2. ANALYSIS OF COMMENTS AND RECOMMENDATIONS

This section contains an analysis of industry-wide response to the recommendations contained in the workshop input document which is included as an appendix.

SUBPART P - EXCAVATIONS AND SHORING

FIGURE 1A: ZONE OF EXPOSURE

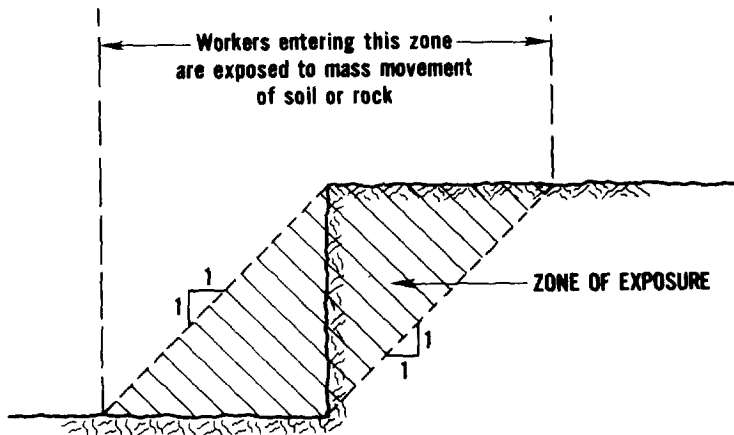
- (a) The regulations contain minimum requirements for the protection of workers in, and adjacent to, excavations against death and injuries. The regulations for shoring, shielding and sloping apply to all excavations in which workers are exposed to effects of mass movement of soil or rock. The zone of exposure is defined in Figure 1A.

- (a) This section contains a scope statement. It states that the regulations are minimum requirements, which may have to be exceeded in some instances. The definition of exposure is added in order to exempt excavations which pose no risk to workers from the regulations.

Figure 1. Effects of nearby foundation loads that must be determined by an engineer

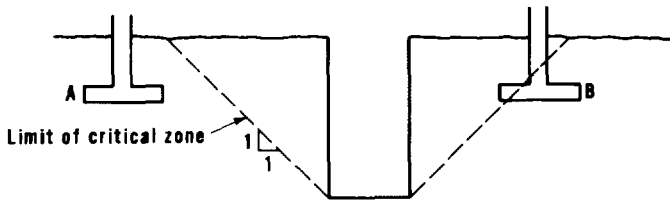
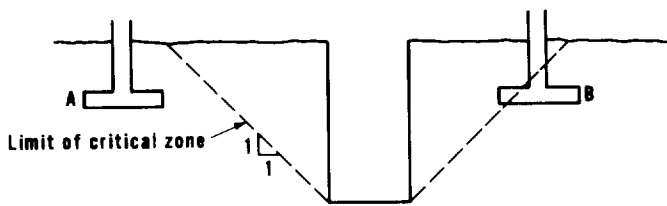
AGC-St. Louis suggested that depth limits for standard practice should not apply to sloped excavations. Efficiency Construction suggested the term "qualified engineer." One important point was made in a joint report of the local sponsors of the Milwaukee workshop (Hayden), as well as by AFL-CIO (Mickle): Any OSHA standard should cover as many situations as possible with standard practice.

- b. An engineer shall determine the shoring, shielding, or sloping requirements whenever the bottom of a building foundation adjacent to the excavation which has not been secured by underpinning extends into the critical zone delineated in figure 1.

Figure 2. Allowable configurations of sloped excavations (cases II, III, and IV are for short-term excavations)

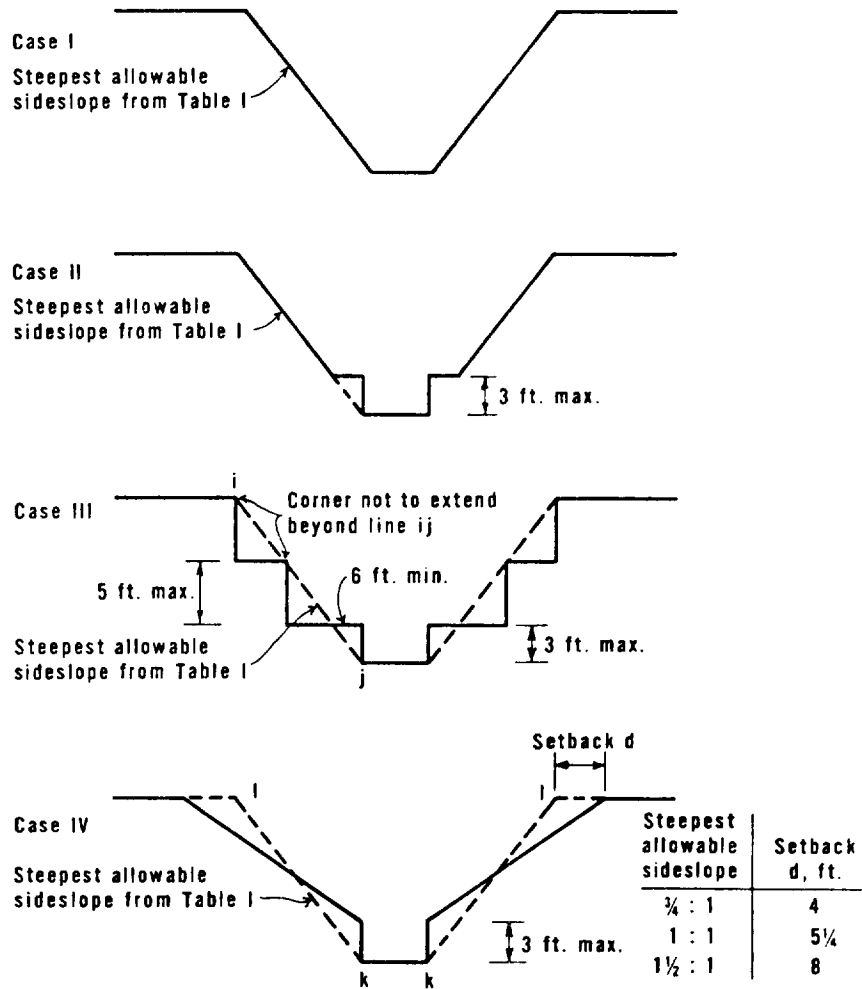
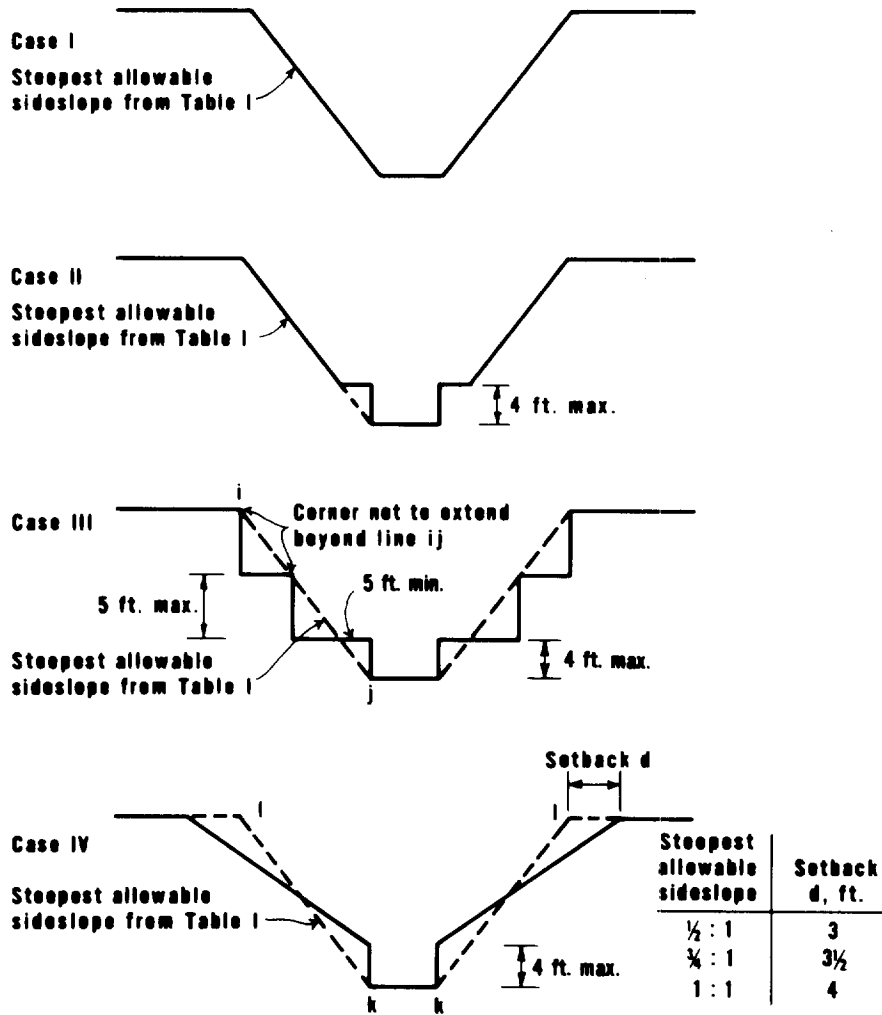
In the Dallas workshop, it was suggested by some contractors to increase the bank to 5 ft (workshop memo). AFL-CIO recommended to leave the allowable height at 3 ft. The point was made that if a large pipe is laid it would provide workers protection against collapse of the bank next to the work area.

The revised sketch is a suggestion rather than a recommendation. It is recommended that industry try to reach agreement on the height of the allowable bank.

Figure 3. Determination of Adjusted Depth

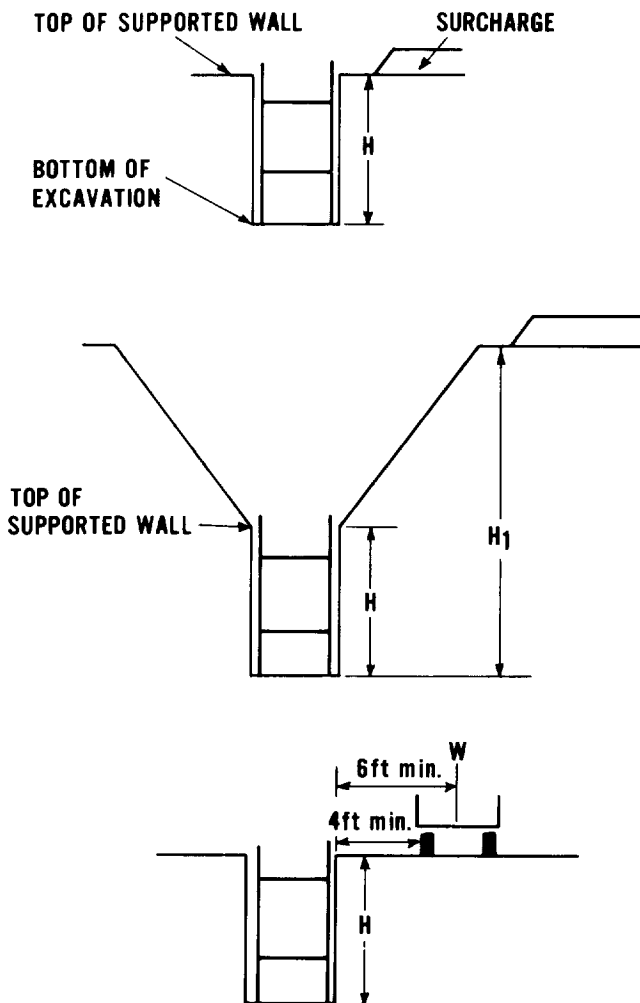
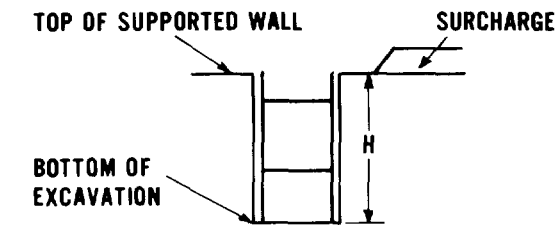
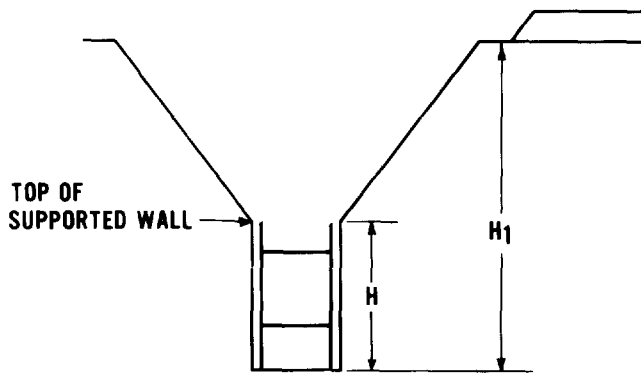
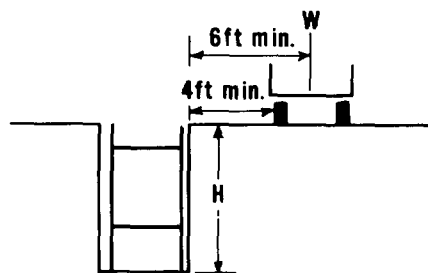
It was suggested to eliminate the protrusion of shoring, as this is many times not used, and frequently not desirable as a means of protection against rolling or sliding objects (Bradberry).

TABLES 2 and 3 NO CHANGE RECOMMENDED
